Title: **QUALITY AUDIT**

**Road Safety Audit Stage 1-2, Access Audit, Cycle Audit and
Walking Audit.**

Proposed Clonburriss SDZ Site for Kelland Homes Ltd.

Report reference: **1470R01**

Drawing - Landscape Masterplan – Ronan Mac Diarmada + Associates Ltd, Perpendicular parking along Road 1.

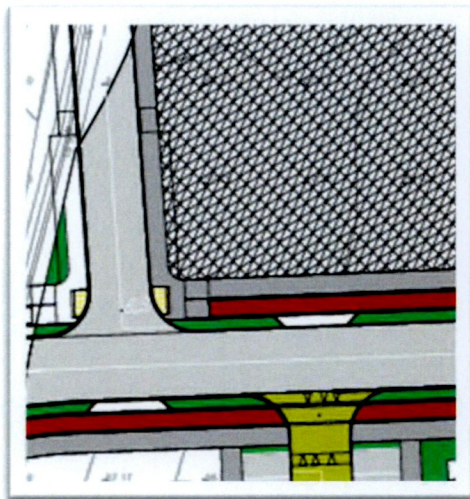
There is perpendicular parking along Road 1 with intermittent landscaped areas between parking bays. There are no other access points for pedestrians, particularly the mobility impaired including those pushing buggies or in wheelchairs to access the apartment block except at the extreme ends of the parking which may be a long way from the desire line.

Red arrows are indicative only to illustrate the issue

It is recommended that intermittent access points for pedestrians be provided.

Drawing P200306-PIN-XX-DR-D-0001-SI P01, P&R realigned access.

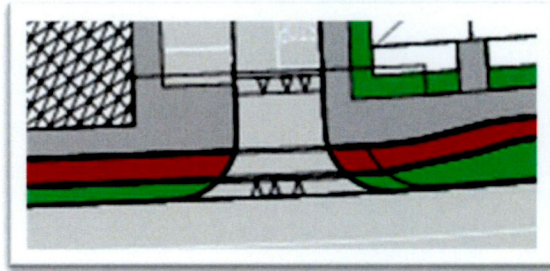
It is proposed to realign the access to the Clondalkin & Fonthill Train Station Park and Ride. It is proposed to provide a footpath only along the access road. There is an existing shared use footway/cycle track to the facility.

It is recommended that facilities be provided for cyclists along the access road.
